Device **C164SV-2R**
Marking/Step **Step (E)ES-AA, AA**
Package **P-TQFP-64**

This Errata Sheet describes the deviations from the current user documentation. The module oriented classification and numbering system uses an ascending sequence over several derivatives, including already solved deviations. So gaps inside this enumeration can occur.

Figure 1 Additional Jitter

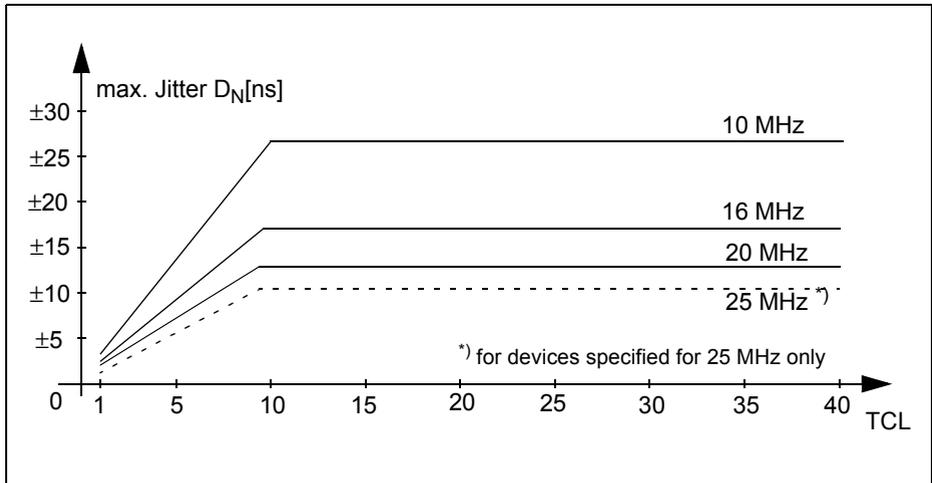
PLL.3.6 Increased PLL Jitter caused by external Access**Problem description:**

In systems where the PLL is used for generation of the CPU clock frequency, the PLL jitter can increase in certain circumstances and exceed the specified value.

The value of the additional jitter is not a fixed one but it depends on the kind of activity on the external bus or output pins. The additional jitter increases with the number of output/bus pins which are switched at the same time to a new voltage level because the problem is caused by noise on the on-chip power supply.

For an accumulated period of $N \cdot \text{TCL}$ the new maximum jitter $D_N[\text{ns}]$, which exceeds the specified value in the Data Sheet, is computed using the formula:

The accumulated jitter is in the specified range for accumulated periods longer than $N = 40 \text{ TCL}$.

In the case that the additional jitter causes problems in the system which cannot be relaxed with software adapted timing parameters the following workarounds are possible:

- If the clock generation is done with the on-chip oscillator then direct drive- or prescaler mode can be used.
- If the maximum frequency of the on-chip oscillator is not sufficient then an external clock generator can be used.

Figure 2 SSCTB Timing

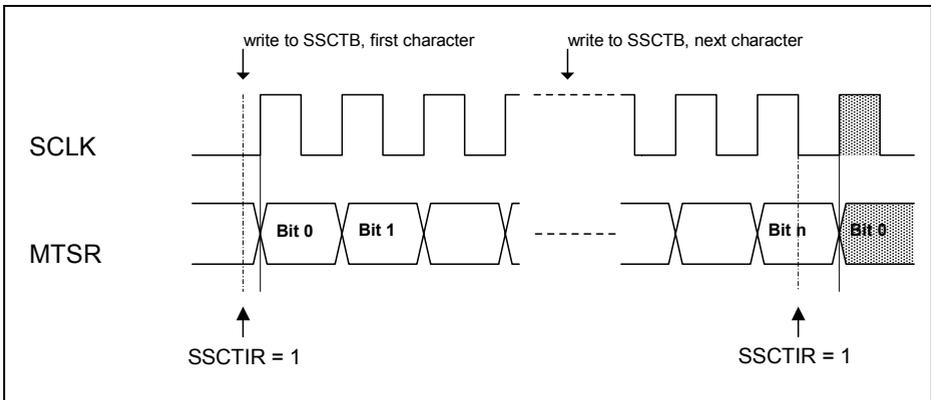
SSC.H2 Timing of flag SSCTIR (SSC Transmit Interrupt Request)

When SSCTB has been written while the transmit shift register was empty (and the SSC is enabled), flag SSCTIR is set to '1' directly after completion of the write operation, independent of the selected baud rate. When the transmit shift register is not empty when SSCTB was written, SSCTIR is set to '1' after the last latching edge of SCLK (= 1/2 bit time before the first shifting edge of the next character). See also e.g. C167CR User's Manual V3.1, p. 12-5.

The following diagram shows these relations in an example for a data transfer in master mode with SSCPO = 0 and SSCPH = 0. It is assumed that the transmit shift register is empty at the time the first character is written to SSCTB:

Typically, in interrupt driven systems, no problems are expected from the modified timing of flag SSCTIR. However, when flag SSCTIR is polled by software in combination with other flags which are set/cleared at the end or at the beginning of a transfer (e.g. SSCBSY), the modified timing may have an effect.

In order to achieve a defined and systematic behavior with all device steps, the SSC receive interrupt, which is generated at the end of a character transmission, may be used instead of the SSC transmit interrupt.
